SUBMITTAL SHEET

Job: 13432
18.49874-JH Gowan North Buffalo Branch
Lone Mountain to Washburn

Submittal Title: AsBuilt Drawings
Submittal Detail:

***GOWAN NORTH BUFFALO BRANCH
LONE MOUNTAIN TO WASHBURN***

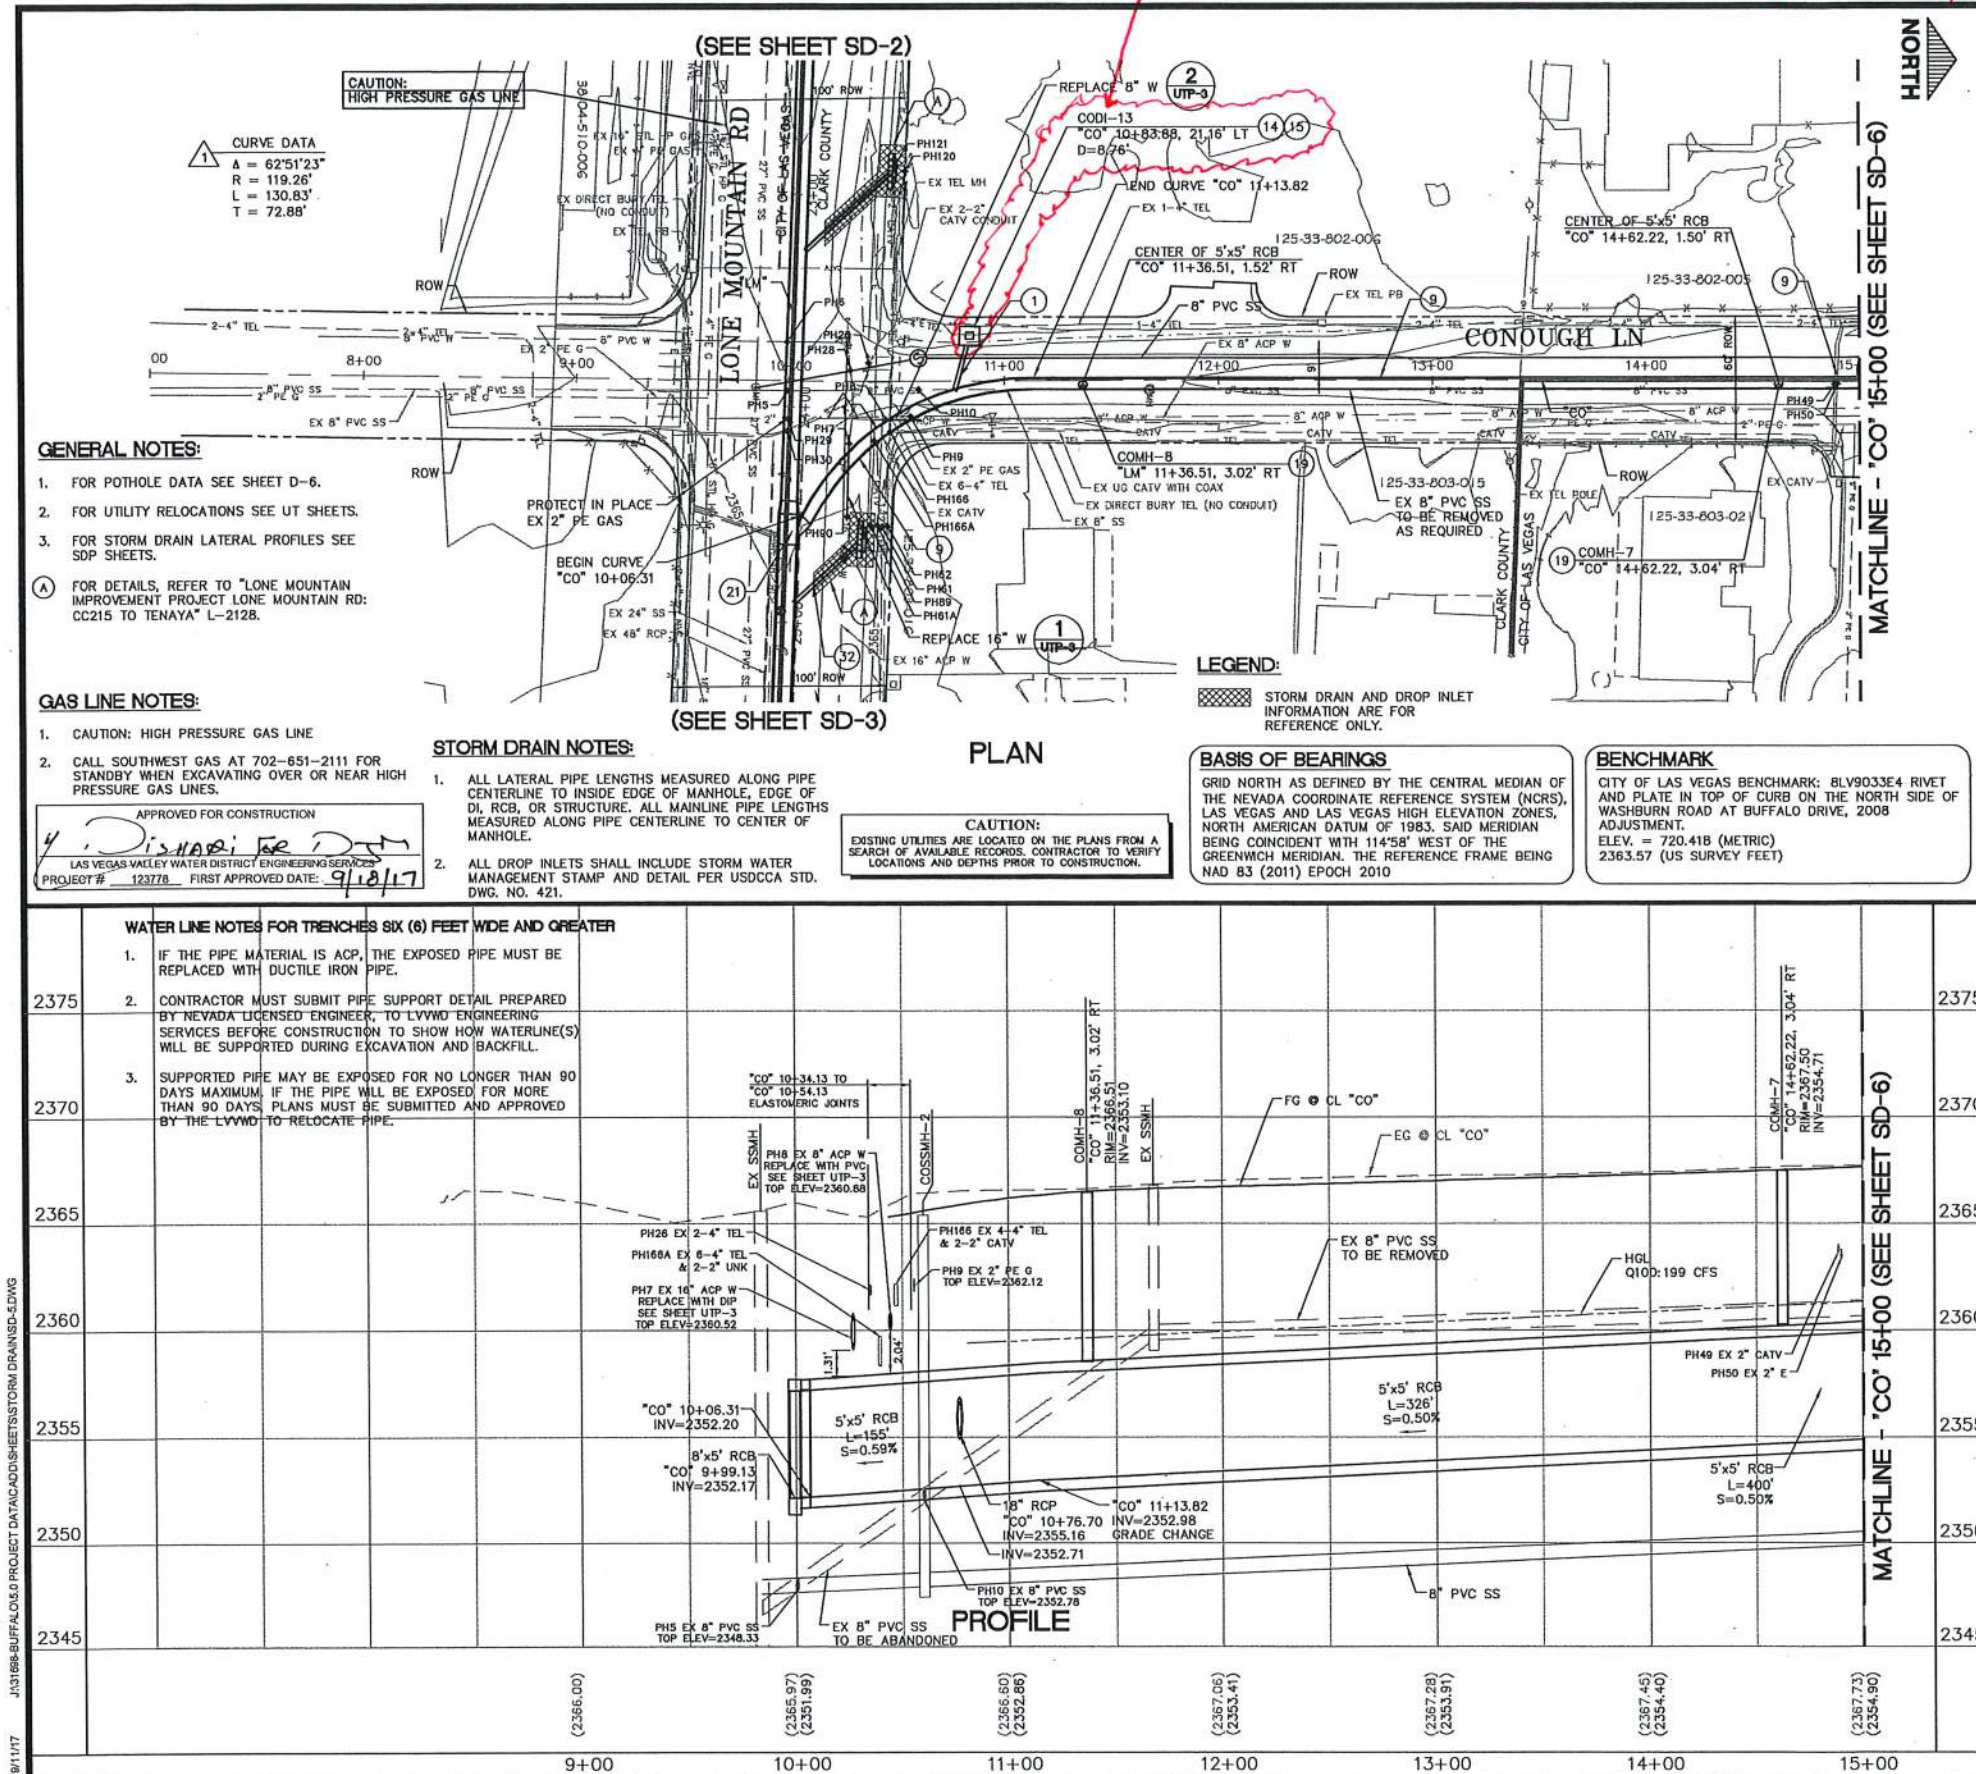
DI# CODI-13 was capped at the grate. By: Lone Mt Road improvements
